COUNTY DEPARTMENT AGENDA REQUEST

Consideration of Petition No. 1213-09, Johnie Williams and JEW Properties, LLC, Owners, and Billy Brundage of Brundage Engineering, Inc., Agent, request to rezone 37.08 acres from A-R to M-1 to construct a maintenance building for Dixieland Fun Park. This property is located in Land Lot 216 of the 5th District and fronts on Corinth Road and Curved Road.

PLANNING COMMISSION REZONING REPORT

PETITION NO.: 1213-09

CONCEPT PLAN

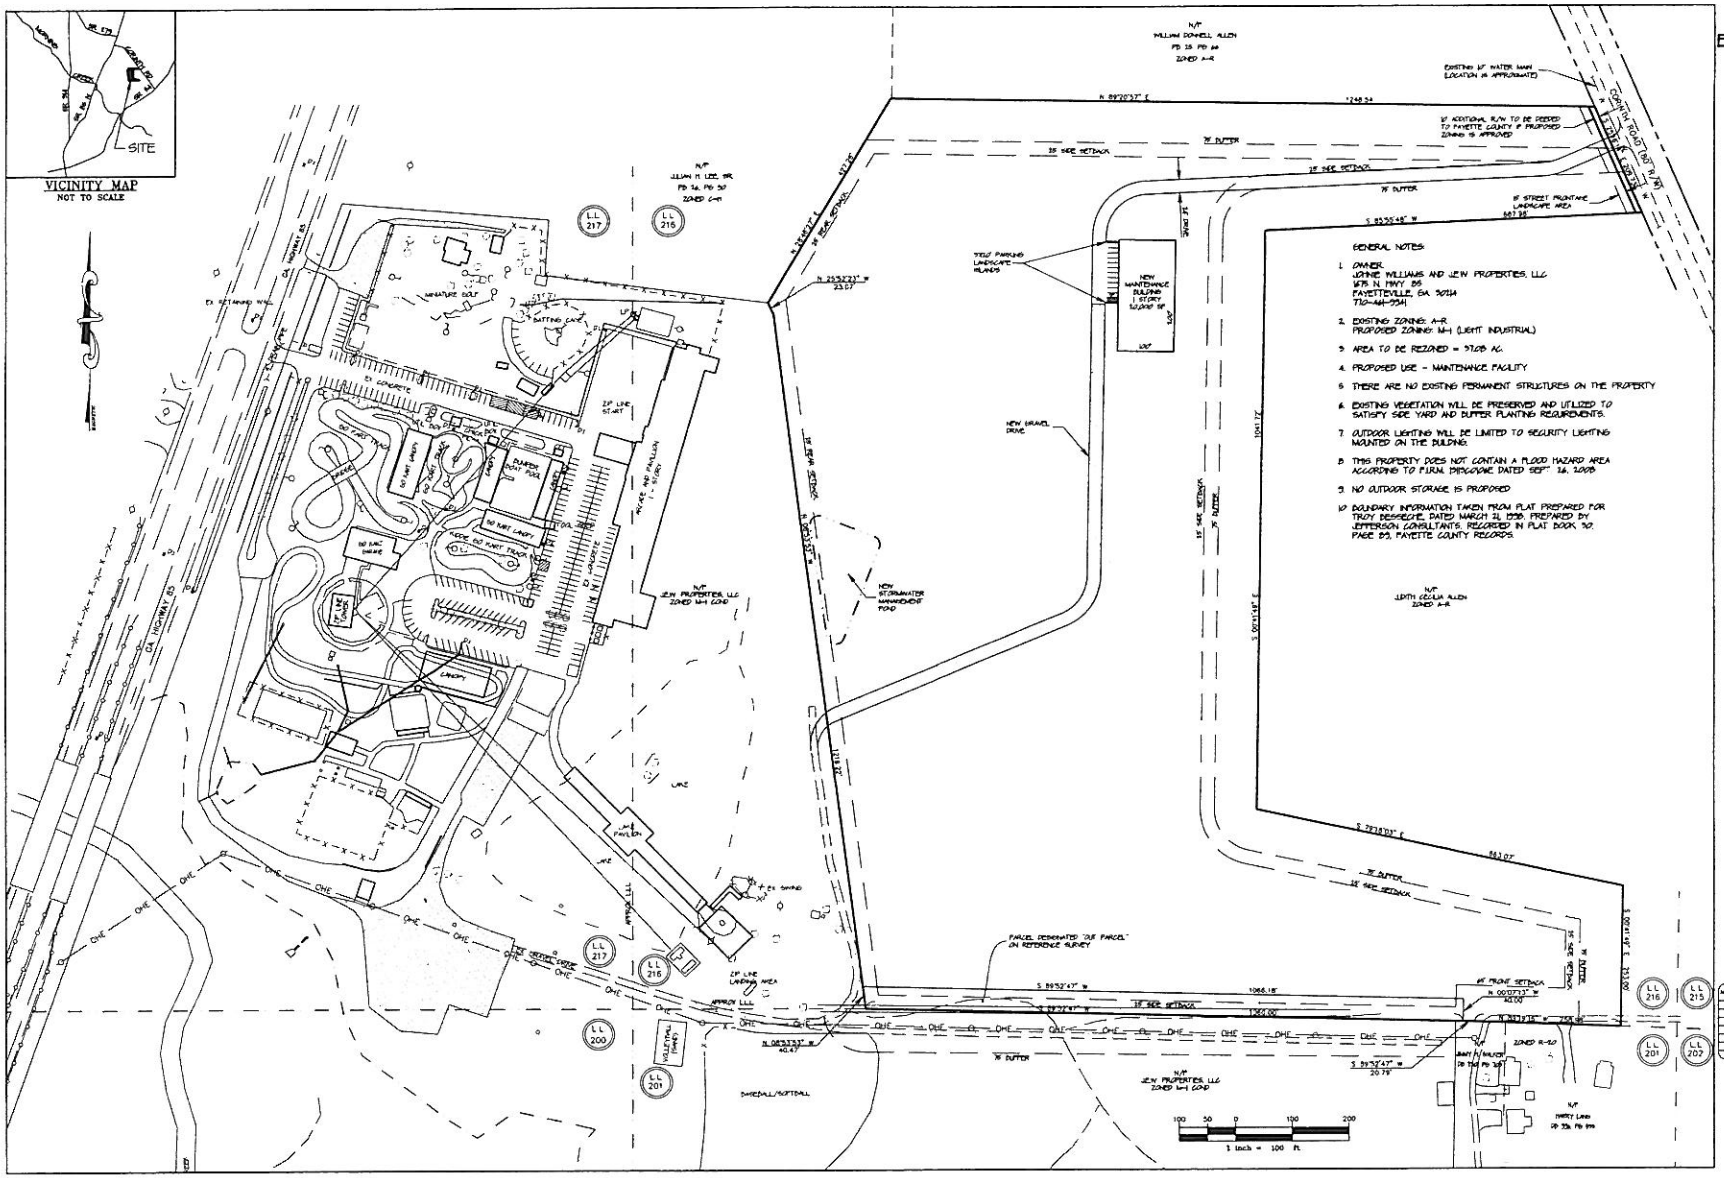
Per the Public Works Director, dedication of right-of-way for Corinth Road is needed to provide 50' of right-of-way as measured from the road centerline. This is shown correctly on the Concept Plan dated 2/25/09. Dedication of right-of-way along Curved Road is needed to provide 30' of right-of-way as measured from the road centerline.

The Concept Plan submitted indicates one (1) access onto Corinth Road.

This property is located within the current territorial boundaries of County Fire Station #1, located on Highway 279, which would provide the initial first responding apparatus to any requests for assistance. Response time for suppression capability from Station #1 would be in the five (5) to eight (8) minute range. Water and hydrants exist along Corinth Road. The concept plan does not show a water line extension or hydrants which will be required.

Dedication of right-of-way along Corinth Road is needed to provide 50' of right-of-way from road centerline and shall be indicated on any applicable Preliminary Plat, Final Plat, or Site Plan. This is shown correctly on the Concept Plan dated 2/25/09.

Dedication of right-of-way along Curved Road is needed to provide 30' of right-of-way from road centerline.

1. The owner/developer shall dedicate, at no cost to Fayette County, per the Public Works Director, as follows: Dedication of right-of-way for Corinth Road is required to provide 50 feet of right-of-way as measured from the road centerline. Dedication of right-of-way along Curved Road is required to provide 30 feet of right-of-way as measured from the road centerline. *(This condition is to ensure the provision of adequate right-of-way for future road improvements per an established policy of the Fayette County Comprehensive Plan and the Development Regulations which stipulate how much right-of-way is needed for compliance.)*

2. The subject property shall not have access to Curved Road. *(This condition is to prevent increased traffic on Curved Road which is not paved.)*

3. An approved site plan and/or traffic study will be required by the County prior to construction of a curb cut and driveway that connects Corinth Road with the Dixieland Fun Park. *(This condition is to lessen the impact of increased traffic on Corinth Road.)*
